IRC Rule Changes for 2026

IRC Technical Committee

This Version: 14 October 2025 (after IRC Congress)

6. A1 – HULL SHELL DEFINITION

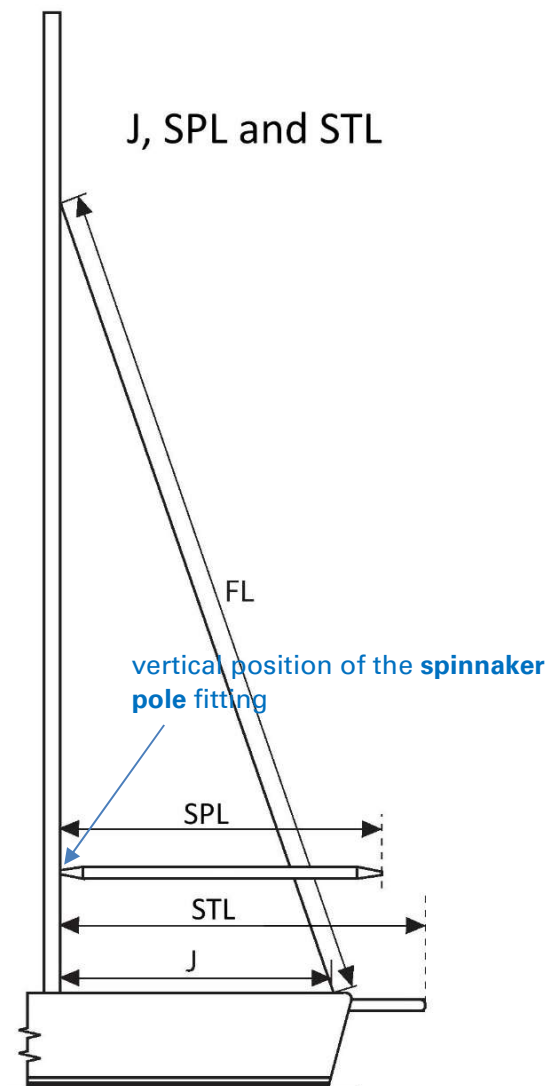
Reason for change: To make it clear that an interceptor (including a vertical transom lip) is not considered part of the hull shell and therefore will not reset the age date. There will be an additional notice explaining the extent of an interceptor that is acceptable. Note that an interceptor that changes hull length will trigger an age date reset in accordance with proposal 5. Either of these additions will still result in a hull factor change as per current practice.

Effect: To make clear that an interceptor is not considered part of the hull shell.

Hull Shell	The hull shell excluding all of the following: any transom (including an interceptor), the deck, any superstructure, the internal structure including any cockpit, fittings associated with these parts and any corrector weights .
------------	--

8. A7 - MAINSAIL MEASUREMENT DEFINITIONS

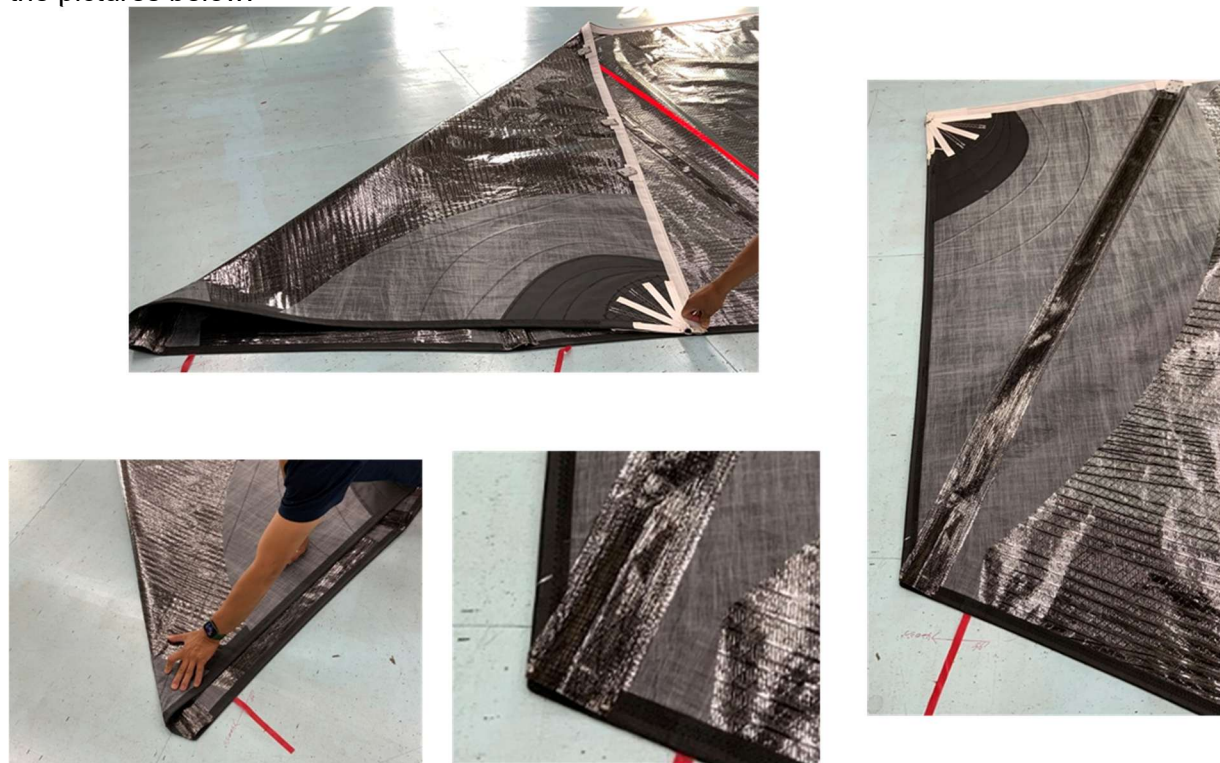
Reason for change: It has been noted that on some square top mainsails the Seven-Eighths Leech Point may be found on the head rather than the leech of the sail as shown in the pictures below:

Whilst it is noted that the number of sails that this will impact is low, it is proposed that an equivalent rule / requirement is added to the IRC Rules for 2026. This will have the additional benefit of making the MUW measurement consistent between IRC & ORC for all sails which will simplify the labelling of sails using the UMS measurement stickers.

MUW The maximum permitted **mainsail seven-eighths width**. **If a seven-eighths leech point cannot be found on the leech, the aft head point shall be taken as the seven-eighths leech point.**
